AMENDMENT OF SOLICITATION/MODIFICATION OF CONTRACT			1. CONTRACT ID CODE J	PAGE OF PAGES 1   3
2. AMENDMENT/MODIFICATION NO. 0007	3. EFFECTIVE DATE 01-Apr-2003	4. REQUISITION/PURCHASE REQ. NO. W81G67-2212-3595		5. PROJECT NO.(If applicable)

14. DESCRIPTION OF AMENDMENT/MODIFICATION (Organized by UCF section headings, including solicitation/contract subject matter where feasible.) This amendment changes specifications and drawings. Two drawings are added and attached. The bid opening time/date is changed to 2:00 PM local time 09 April 2003.				
Except as provided herein, all terms and conditions of the document referenced in Item 9A or 10A, as heretofore changed, remains unchanged and in full force and effect.				
15A. NAME AND TITLE OF SIGNER (Type or print)			16A. NAME AND TITLE OF CONTRACTING OFFICER (Type or print)	
			TEL:	EMAIL:
15B. CONTRACTOR/OFFEROR	15C. DATE SIGNED	16B. UNITED STATES OF AMERICA		16C. DATE SIGNED
_____ (Signature of person authorized to sign)		BY _____ (Signature of Contracting Officer)

WAHPETON STAGE 1  
**FLOOD CONTROL**  
 STORM SEWER DETAIL

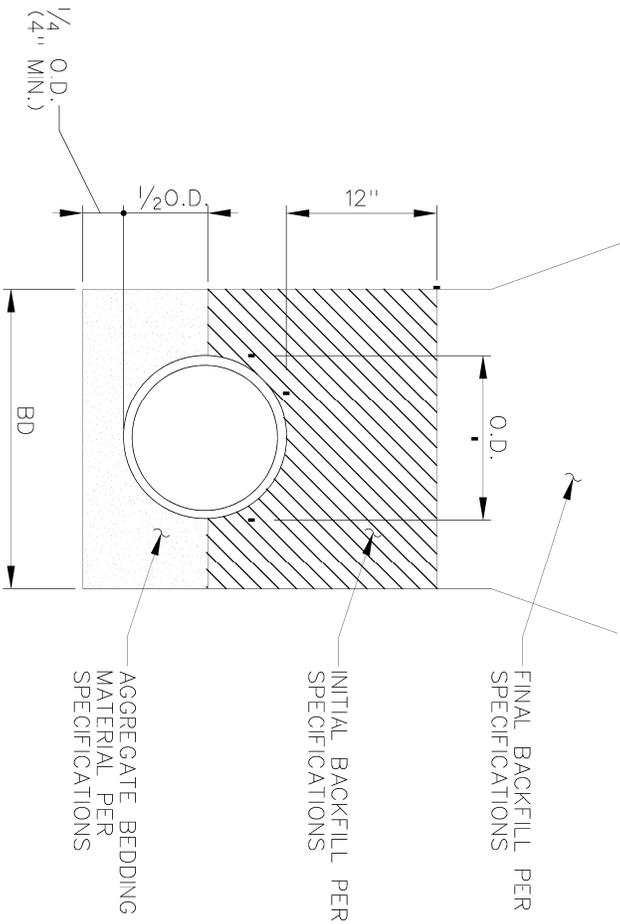
3. Section 02300. Add the following paragraph after paragraph 3.3.1:  
 "3.3.2 Additional Permanent Stockpile Area Not Shown on Drawings  
 An additional permanent stockpile area, not indicated on the drawings, is located just north of Ponding Area 2A. All excavated material from Ponding Area 2A, meeting the requirements indicated in the above paragraphs, shall be placed in this stockpile area. Material shall be placed as indicated in the above paragraph pertaining to placement requirements. The sketch at the end of this section shows the layout, dimensions, top elevation, and side slopes of the stockpile area. The sketch also shows work limits and access to the area from the adjacent dirt road. The actual work limits and stockpile boundaries shall be field located by the Contractor based on this information and approved by the Contracting Officer prior to using the area."

4. Section 02300. Insert the attached sketch, showing the additional permanent stockpile area, at the end of section 02300.
5. Section 02316, after paragraph 2.1.4, add the following paragraph:  
 "2.1.5 Aggregate Bedding Material  
 Aggregate bedding material shall be a well graded mineral product meeting the following gradation requirements:
